Former Bauer Millet Site - Manchester

MMA PLANNING APPLICATION - LIST OF AMENDMENTS & MARKED UP DRAWINGS | 06 APRIL 2022

10053-MP-A-B5D9-MMA-003 | REV 01

Drawing Title: Building 3 - Section AA

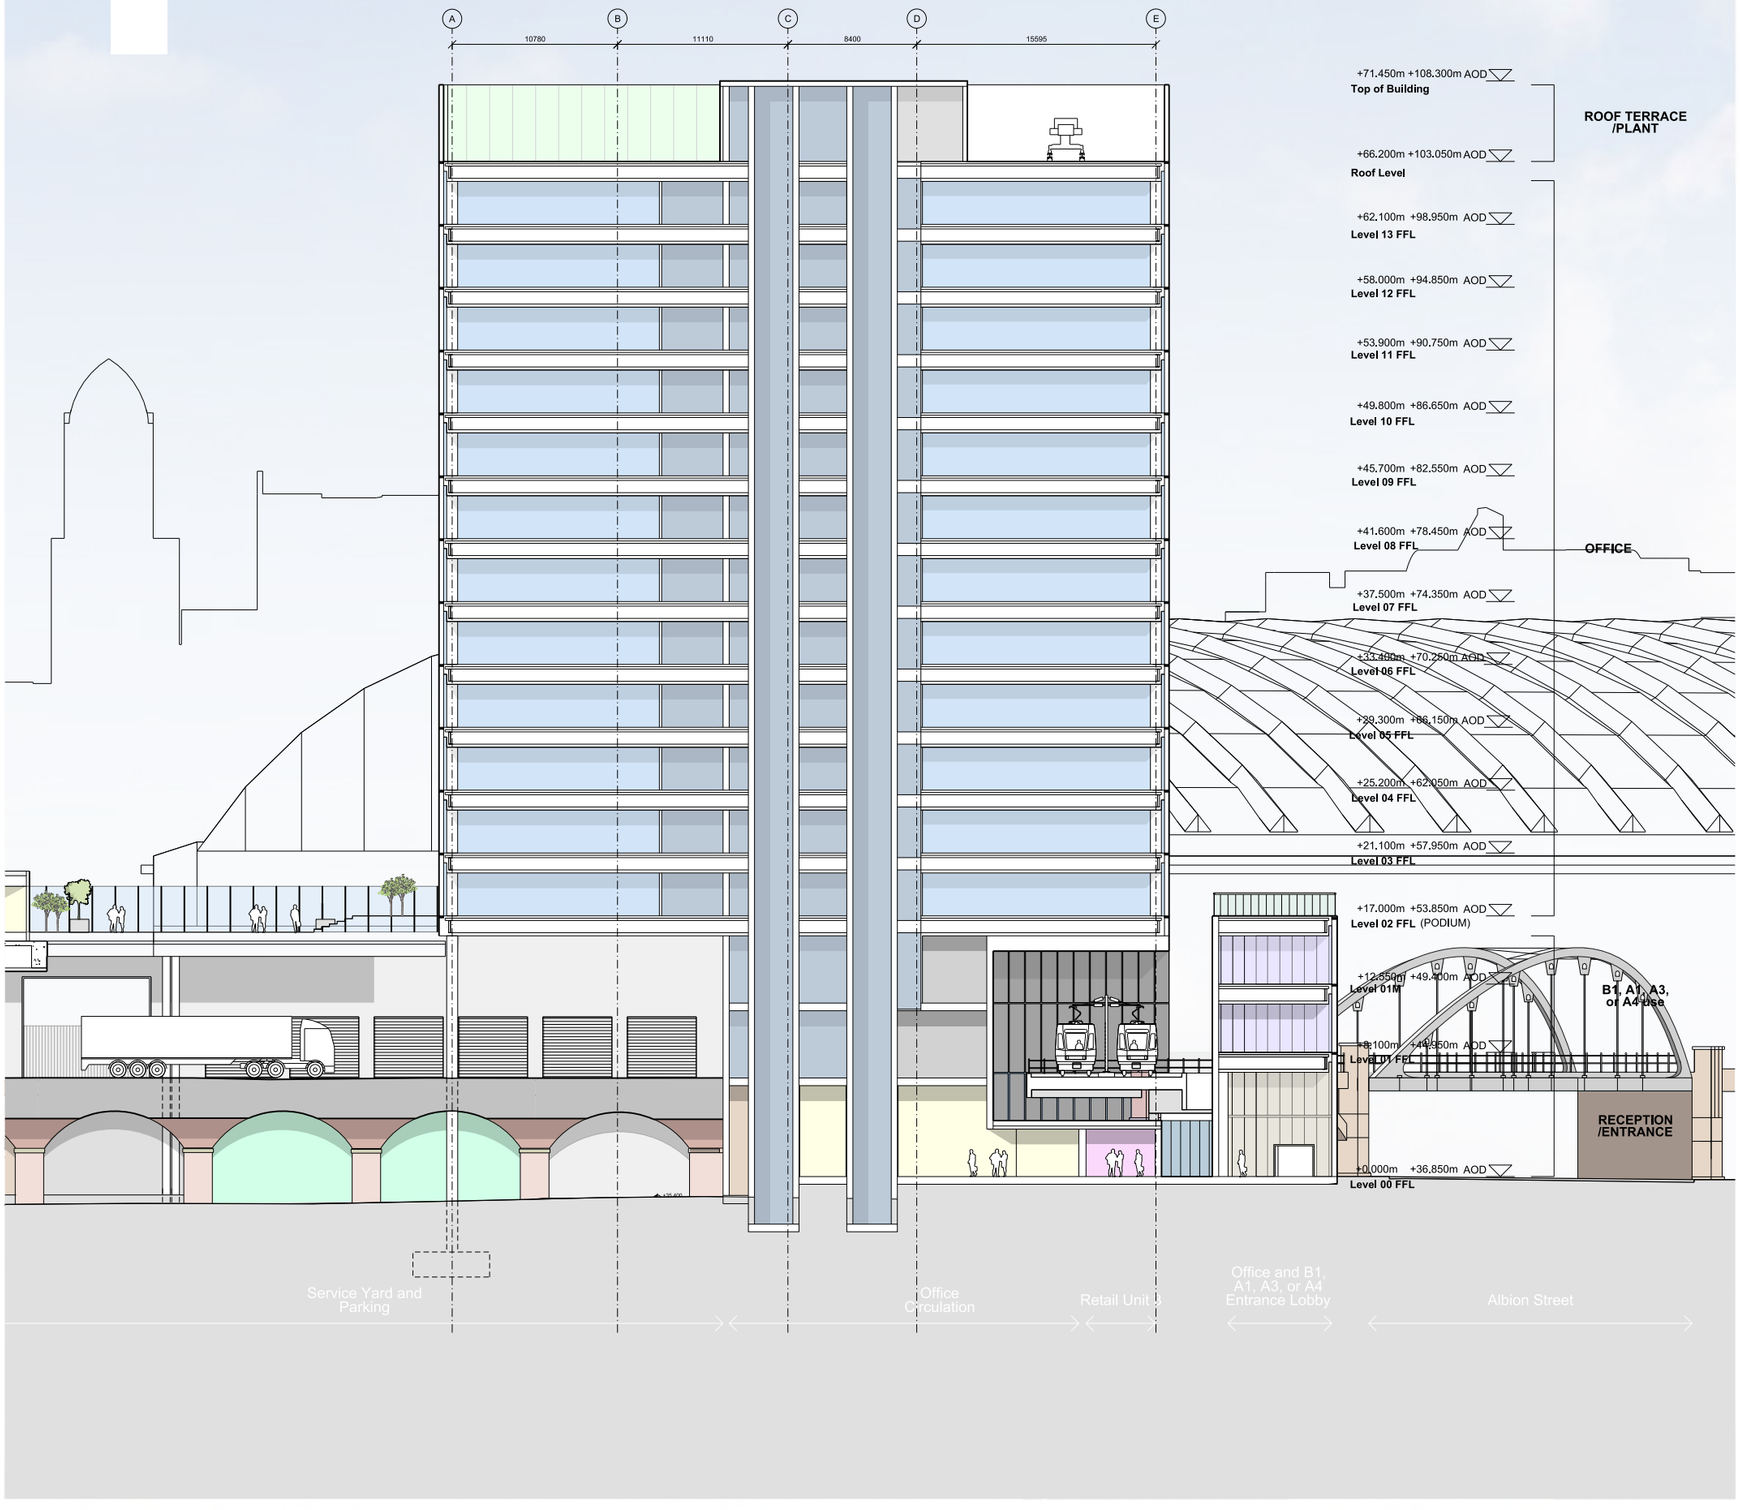
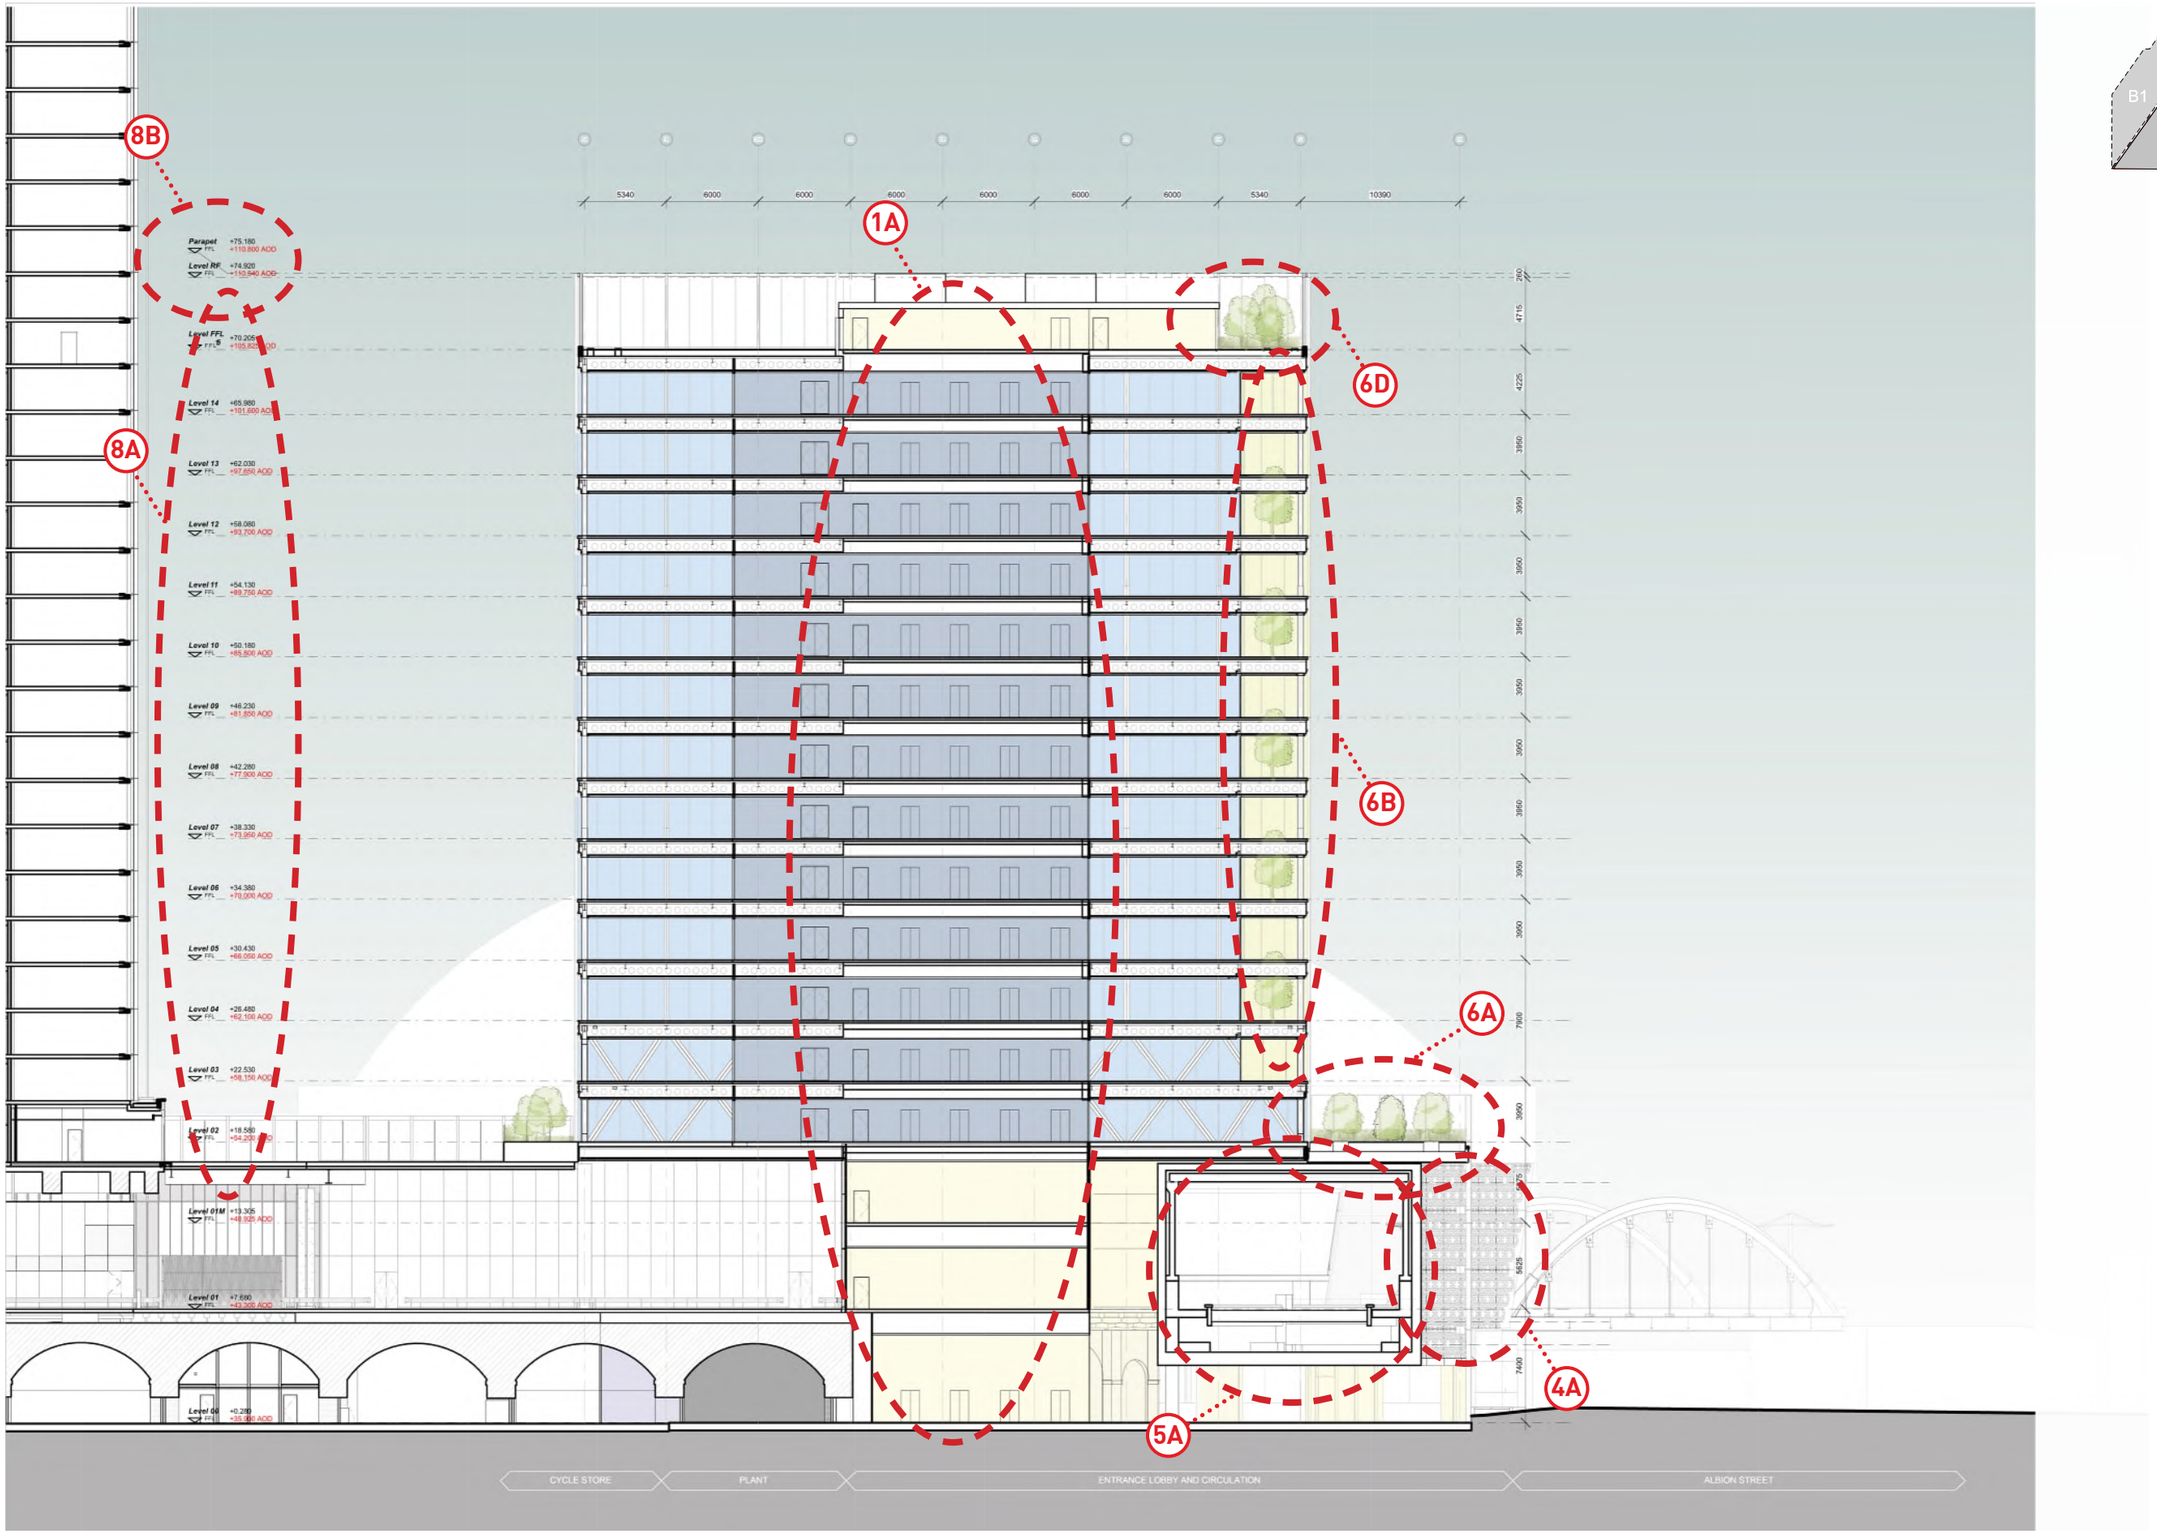
A - The office floor to floor height has been revised following a review of the main structural beam depth and the client decision to have exposed soffits and services with no ceilings.

As a result the floor to floor height has been revised from 4100mm to 3950mm with a 2900mm floor to underside of structure. (BCO Guide to Specification - Best practice for offices – 2019 recommends a clear height of 2.8 to 3.2m for spaces over 18m in depth).

B - The overall reduction in height of 1450mm (1800mm - 350mm) resulted in the decision to add a further office floor (3950mm) which results in an overall increase in height of 2500mm.

PROPOSED PHASING - LEVEL 00

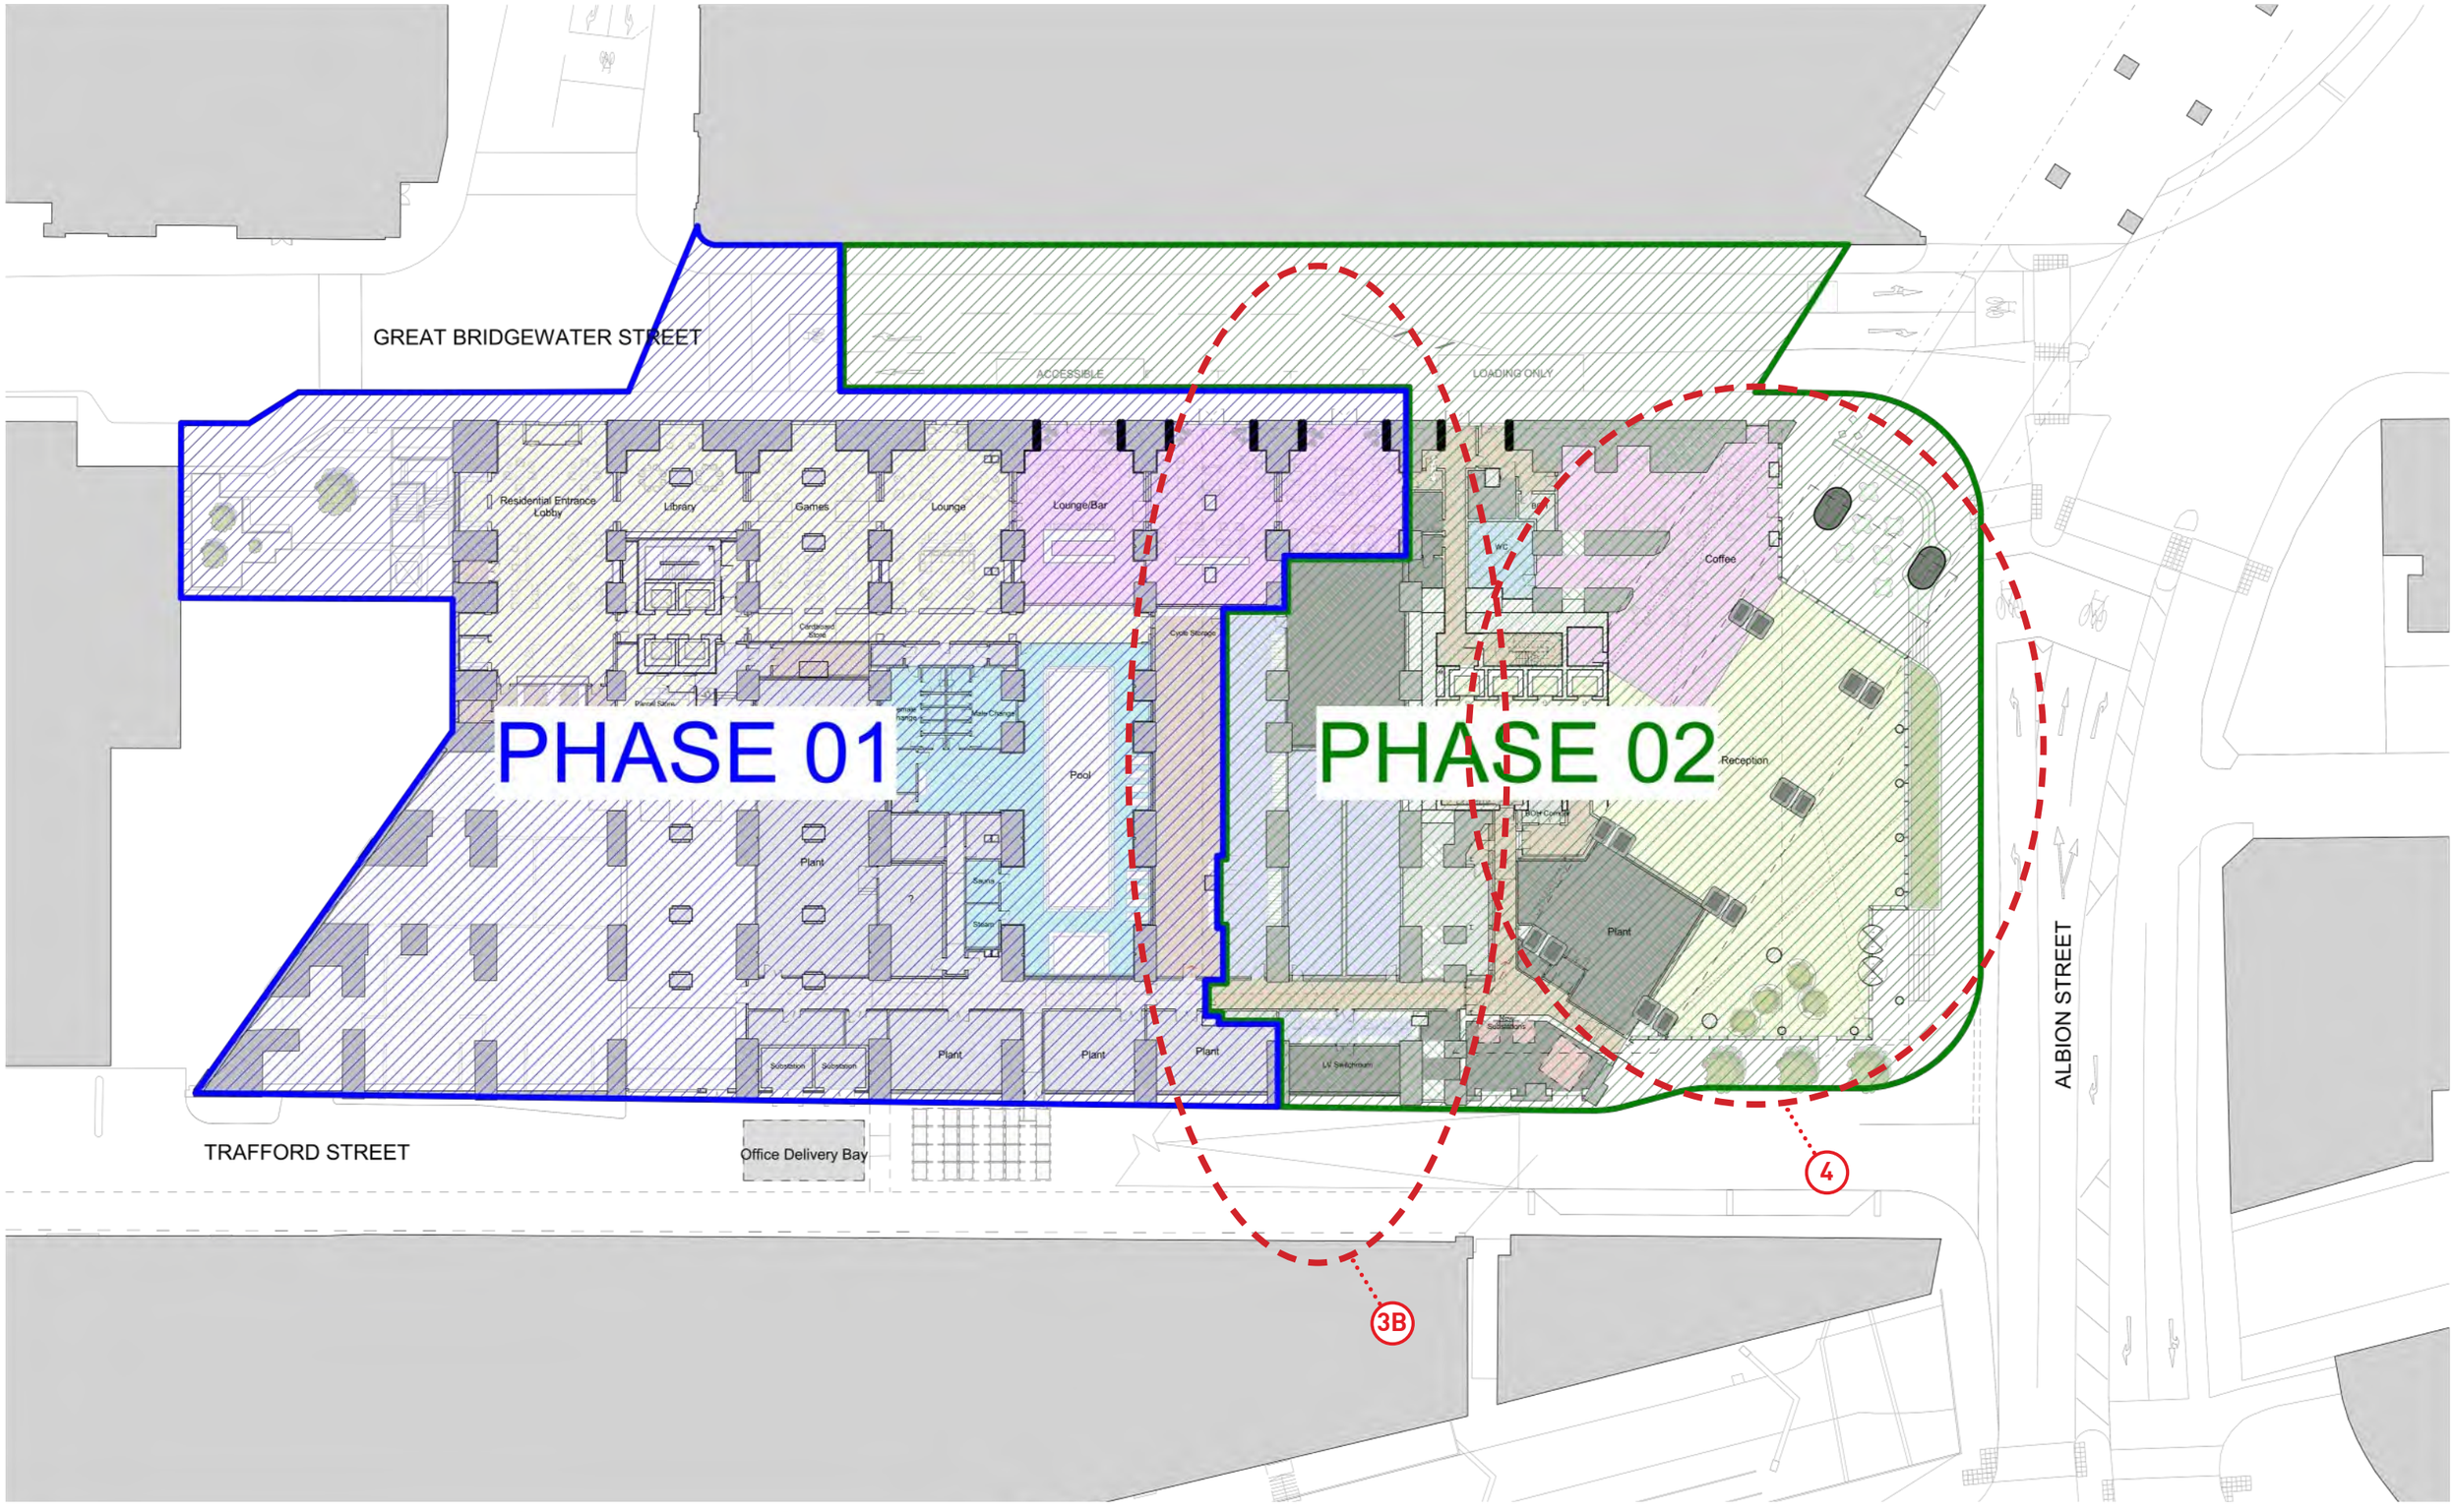
B - This results in a change to the phasing at ground floor with the lounge bar being constructed as part of phase 1.
